Technical BULLETIN

SAFETY RECALL

CERTAIN 2015-2016 YZF-R3F/G MODELS

FACTORY MODIFICATION CAMPAIGN – Clutch Pressure Plate and Oil Pump

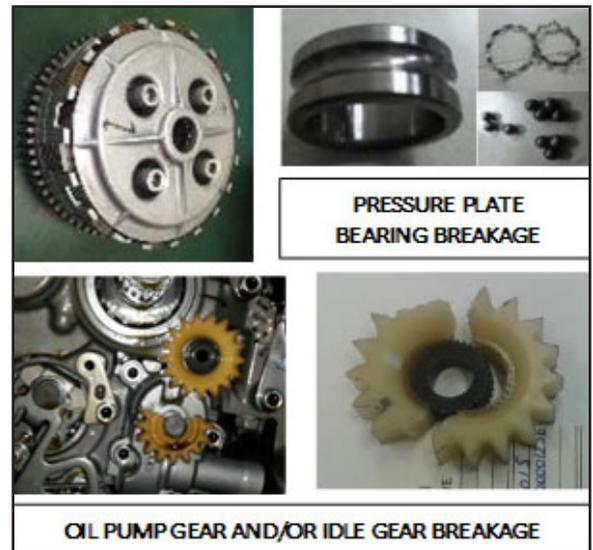
To correct these defects, Yamaha is initiating a Factory Modification Campaign. Affected units must have the clutch pressure plate assembly and oil pump assembly replaced with parts of a different design.

Part Name	Old Part	New Part
Pressure plate assy 2MS	<p>STAMP</p> <p>2MS</p> <p><2MS-E6350-00></p>	<p>STAMP</p> <p>2MS2</p> <p><2MS-E6350-09></p>
Oil pump assy	<p>NO PUNCH MARK</p> <p><1WD-E3300-00></p>	<p>PUNCH MARK ADDED</p> <p><1WD-E3300-09></p>

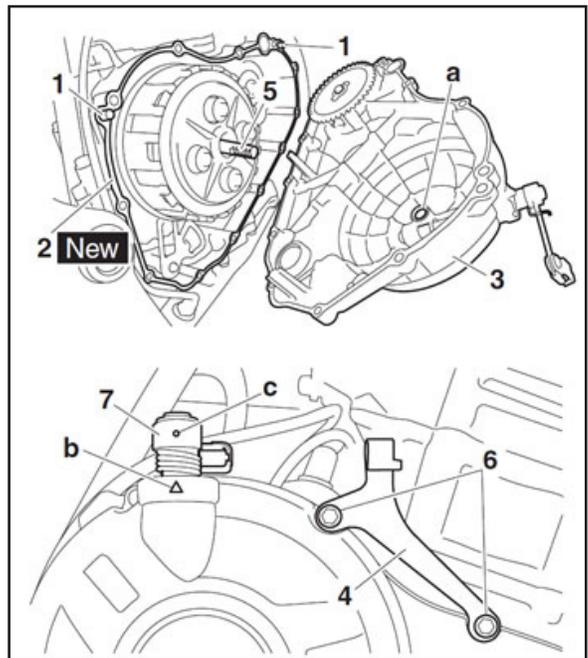
- Face the serrations on the clutch pull rod “5” rearward and align the rod with the hole “a” in the clutch cover.
- Make sure the pull rod teeth and pull lever shaft pinion gear are engaged.
- Apply locking agent (LOCTITE®) to the threads of only the clutch cable holder bolts “6” shown in the adjacent illustration.
- Tighten the bolts in stages and in a crisscross pattern.
- After installing the clutch cover, make sure the alignment mark “b” on the clutch cover is aligned with the punch mark “c” on the pull lever “7.”

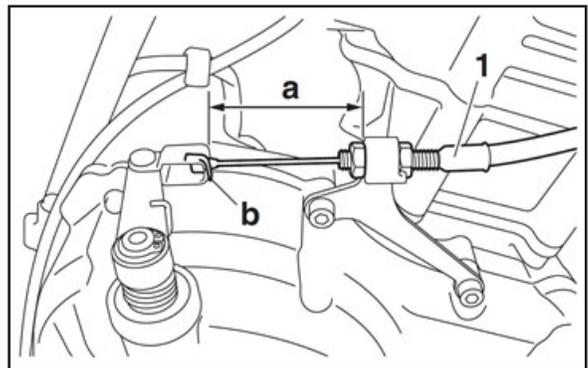
- Install the clutch cable so the clutch cable length “a” is 52.6-64.1 mm (2.07-2.52 in) as shown in the adjacent illustration.
 - After installing the clutch cable, bend the projection “b” on the pull lever as shown in the adjacent illustration.
9. Reinstall the bodywork removed during step 1 and verify the clutch cable free play is within specification.
